**AERONAUTICAL CHARTING FORUM**  
**Charting Group**  
**Meeting 14-02 – October 28 - 30, 2014**

**RECOMMENDATION DOCUMENT**

**FAA Control # ACF-CG RD 14-02-286**

**Subject: Airport Diagram Symbol for Non-Standard Runway Holding Position Marking in Conjunction with a Hot Spot**

**Figure 1 - Seattle-Tacoma International (SEA 9/24/2014)**

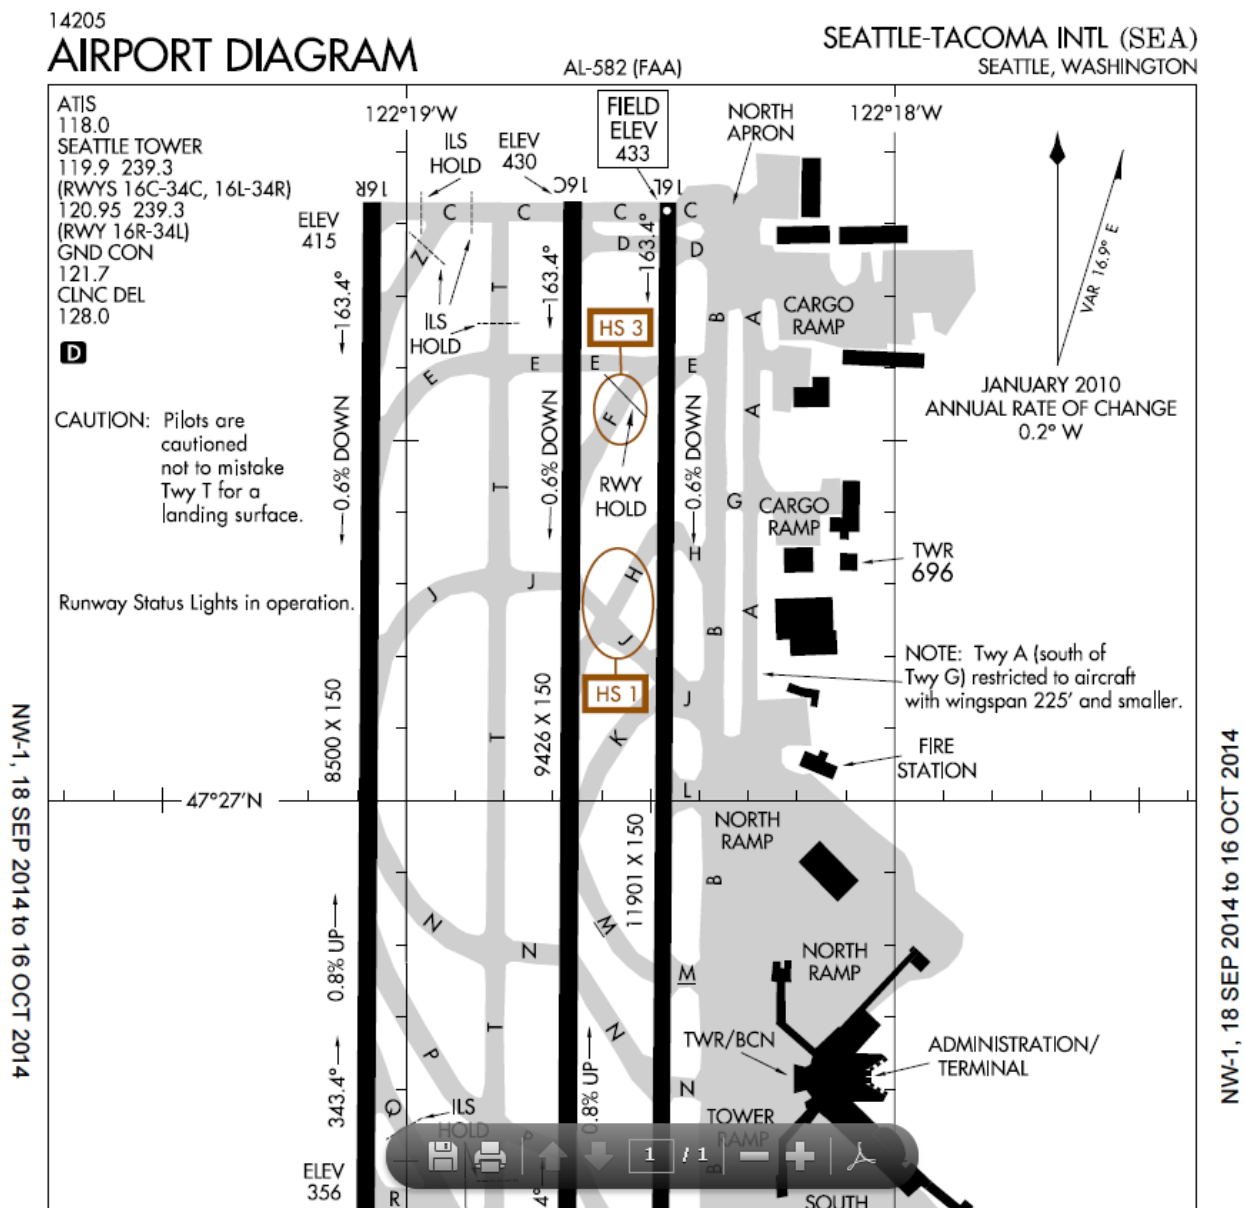
Runway Incursions have been attributed to pilots crossing runway holding position markings because the markings were placed in an unexpected or non-typical location. Such is the case in SEA. Several Runway Incursions (RI) took place in SEA at Taxiway Foxtrot and Runway 34R, one of which involved an air carrier aircraft missed the markings and crossed under a departing air carrier aircraft. In this case, Taxiway Foxtrot is a taxiway that meets the runway entrance at an angle and the holding position marking is unexpectedly encountered prior to the entrance. (See graphic at the end of this document.) Actions taken to mitigate this threat included the then Director of Runway Safety, Wes Timmons, coordinated with charting to chart the runway holding position marking location and published a hot spot. The following is the hot spot description that was published as a result of the RIs that took place at this location on SEA airport.

Please see image of Hot Spot 3 and SEA airport diagram at the end of this document.

Remove the prohibition against showing non-standard hold lines in conjunction with a Hot Spot that already exists for this purpose. In short, publish both the hot spot AND the hold line.

Valerie Watson, AJV-553, reviewed the history of the issue and provided an update of actions taken since last ACF. Valerie stated that the charting specifications have been updated to allow a non-typical runway hold location in conjunction with a hot spot to be depicted on airport diagrams.

**Figure 2 - SEA HOT SPOT 3**

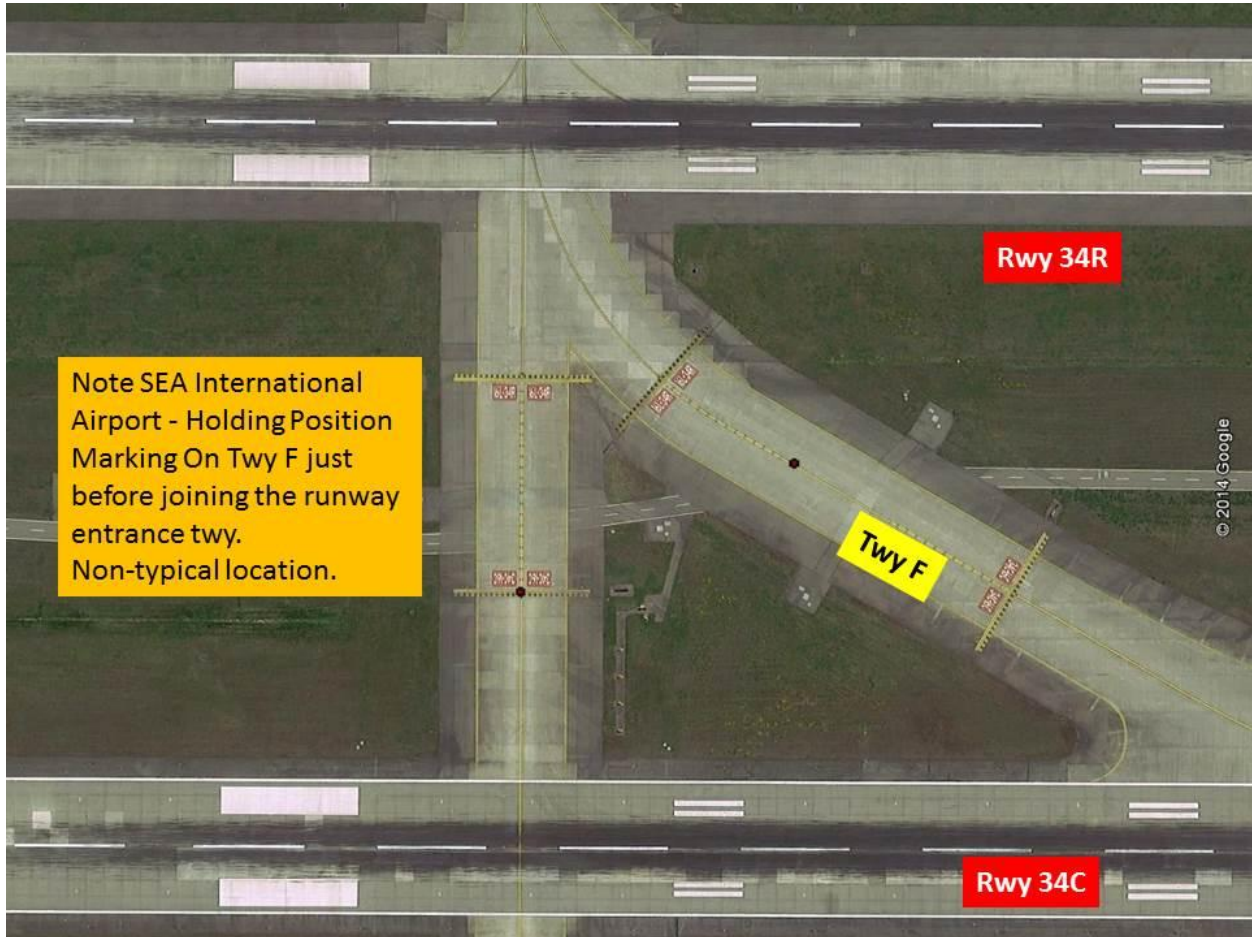
HS 3            Acft exiting Rwy 34C at Twy F sometimes enter Rwy 34R without authorization, taxi distance is very short and pilots should use caution to stop at hold line unless authorized to cross the rwy.
